Tiptree Neighbourhood Plan (Consultation Edition) 2019: Submission on behalf of Colchester United Football Club – Florence Park Redevelopment, Grange Road, Tiptree

Tiptree Neighbourhood Plan: Consultation Edition

Re: Tiptree Neighbourhood Plan: Consultation Edition

Representations on Tiptree Neighbourhood Plan

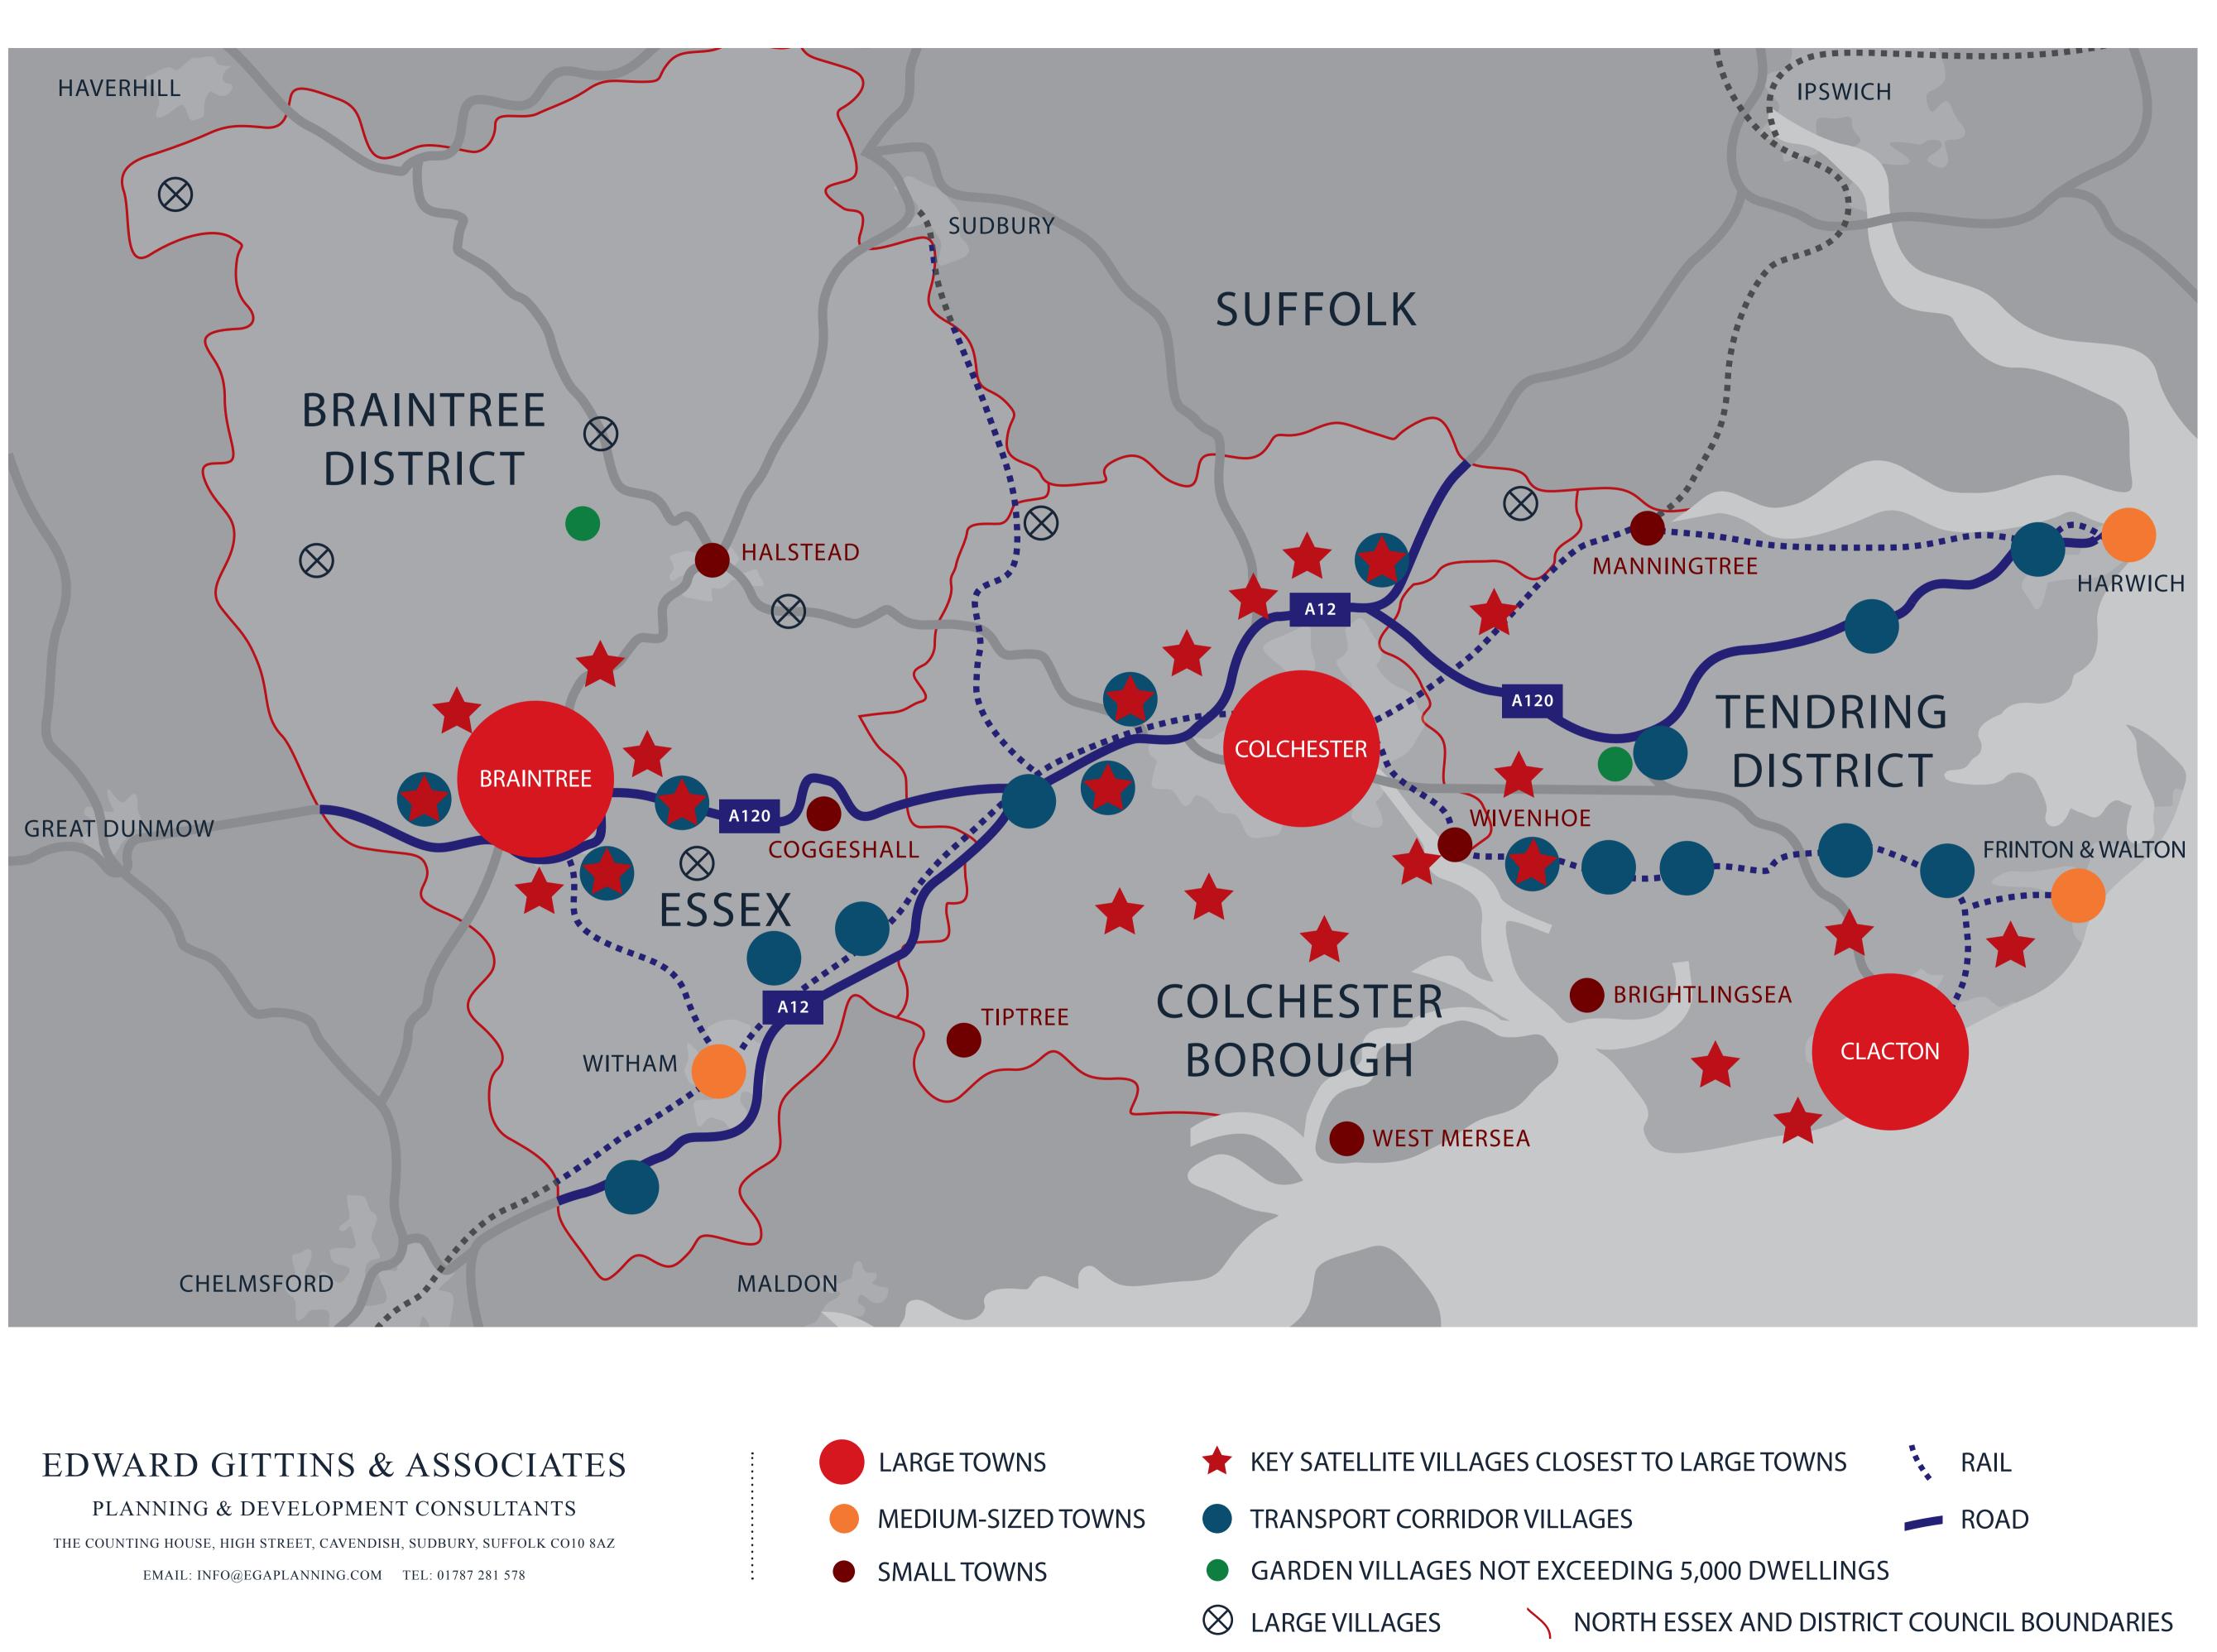
The Site Plan therefore defines a proposed amendment to the settlement boundary in the draft Tiptree Neighbourhood Plan: Consultation Edition.

The proposed amendment to the settlement boundary is shown on the attached Tiptree Policies Map as it appears in the draft Tiptree Neighbourhood Plan Consultation Edition and it is respectfully requested that this amendment be made prior to the Examination and adoption of the Neighbourhood Plan.

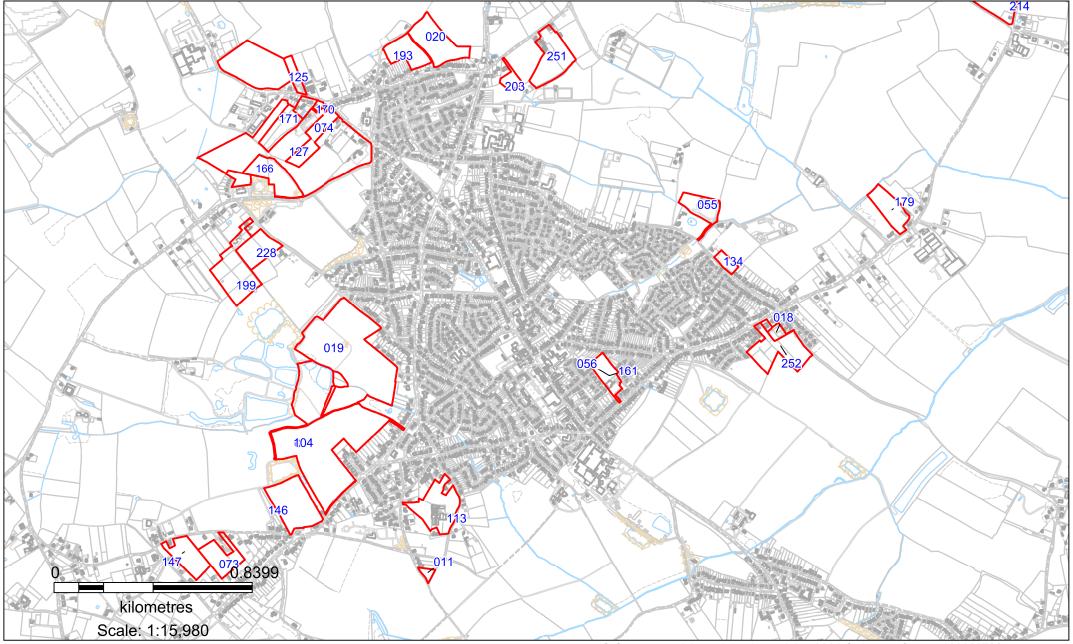
The frontage site on Grove Road is shown on the attached Site Plan and is put forward as a small infilling/rounding-off site on the edge of Tiptree. Its release would represent the natural completion of development on this section of Grove Road and would supplement the limited supply of small sites available within the existing built-up area of Tiptree.

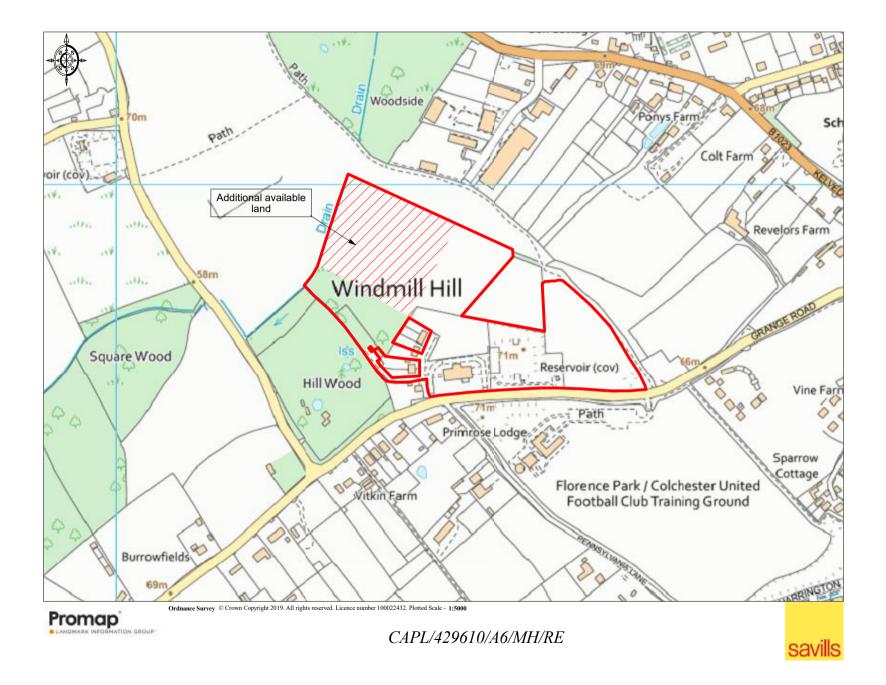
Essex & Suffolk Water support this allocation. However, they would stress that the water works and surrounding land is extensive, highlighting an area of 2.50 Ha to the west of the proposed 'Tower End' residential allocation. This land is available for development and is well related to the proposed allocation. It is considered that this land should be included in the allocation to allow flexibility in the delivery of the proposed housing and could allow for additional housing, open space or biodiversity enhancements if required as part of any planning application. This land is shown on the attached plan.

It is also important to note that Essex & Suffolk Water will require an operational easement on the south easterly most section of the proposed allocation where the new access is proposed on Grange Road. Whilst a road could be located over the easement, residential property could not. Ultimately this may affect housing numbers across the allocation. Acknowledging this, there would be significant benefit in extending the allocation to include the 2.50 Ha referenced above, the land being available and appropriate for development.

In any event it is important that a new criterion is added to the policy to ensure that the operational mains running across the southern most portion of the site are protected. This should state the following:

The operational water mains across the site should be protected from development to ensure that access can be maintained
